**Review of EPA's Section 111
May 23, 2023 Proposed Rule for the
State of South Carolina**

**South Carolina
Office of Regulatory Staff**

August 8, 2023

Prepared By:
J. Kennedy and Associates, Inc.

Figure 13: CEC Nameplate Capacity

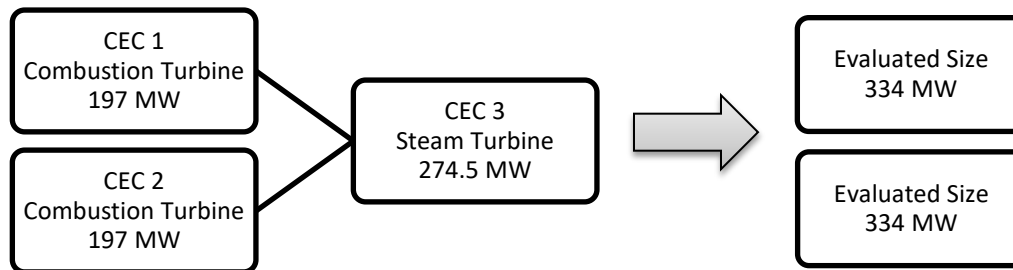
The EPA provided clarification on July 7 that described how to evaluate the size of CC units such as CEC. Per the EPA's Memo, the steam turbine capacity should be allocated equally between the two CTs, and then an assessment should be made whether the two CTs exceed the 300 MW threshold; however, the EPA did not mention which capacity ratings should be used.⁴⁶ Based on the nameplate rating data DESC supplied, the EPA's calculation implies that each of the CEC CT's is 334 MW in size ($197 + .5 (274.5) = 334$ MW), which exceeds the 300 MW threshold limit, and therefore, means that CEC would have to comply with the Proposed Rule. If DESC's winter ratings were used, in which CT1 and CT2 are rated 192.1 MW and 169.0 MW, respectively, and the steam turbine is rated at 259.6 MW, then CT1 would have to comply ($.5 * 259.6 + 192.1 = 321.9$ MW), but CT2 would not have to comply ($.5 * 259.6 + 169.0 = 298.8$ MW).

Comment: EPA should define summer, winter, or nameplate as the threshold when considering a finalized rule.

Figure 21: Comparison of CO₂ Emissions by Case

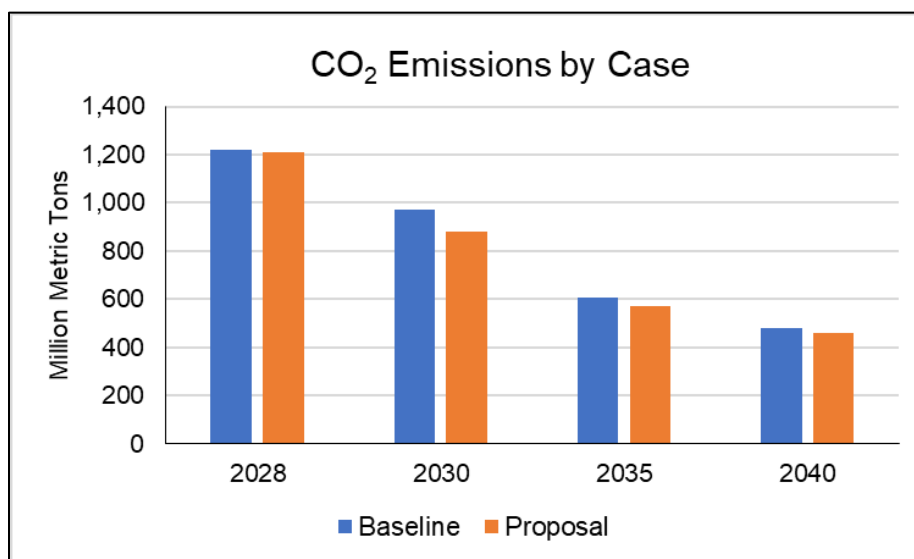
Again, the EPA expects there will be a dramatic reduction in CO₂ emissions in the Baseline Case, and in fact, there will be little additional reductions in CO₂ emissions as a result of all of the requirements from the Proposed Rule. If the IRA is projected to yield greater reductions in CO₂, the Proposed Rule appears to be unnecessary at this time. This leads to the question of, “Why is the IRA not enough?” However, if the EPA overestimated the amount of CO₂ reductions in the Baseline case, then the EPA likely grossly understated the costs that will occur as a result of the Proposed Rule.

Figure 22: GREET Model Presentation⁷³
Well-to-gate (WTG) GHG emissions of hydrogen production pathways

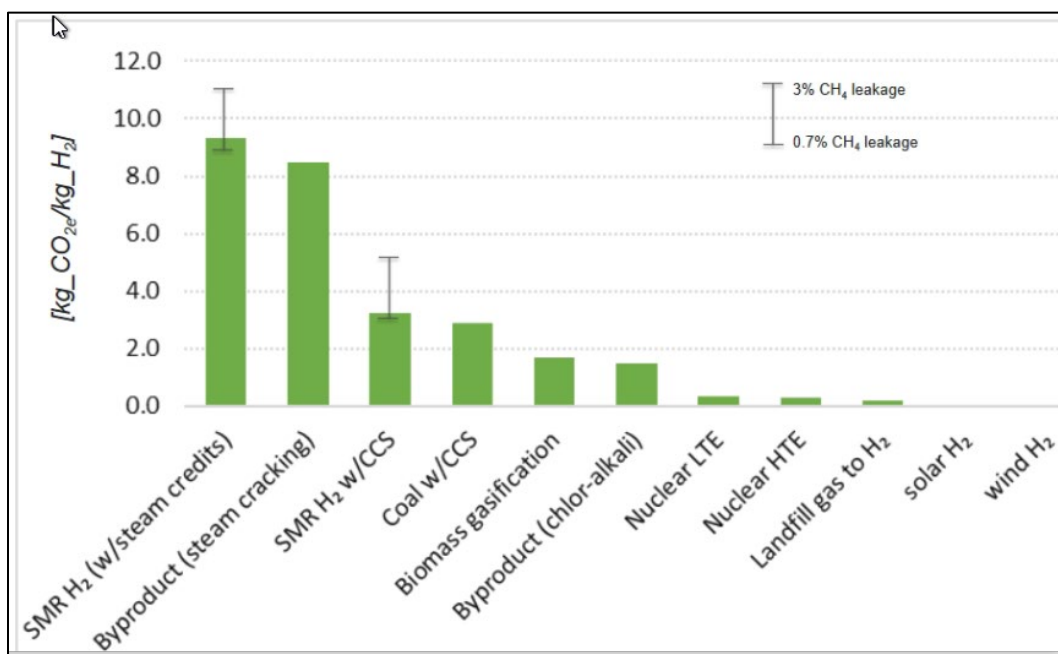
There are other significant questions associated with the use of low-GHG hydrogen including the fact it is expensive to produce, costly to transport, and will require major technology breakthroughs to achieve the level of co-firing using hydrogen that the Proposed Rule assumes, 30% by 2032 and 96% by 2038, just six years later.
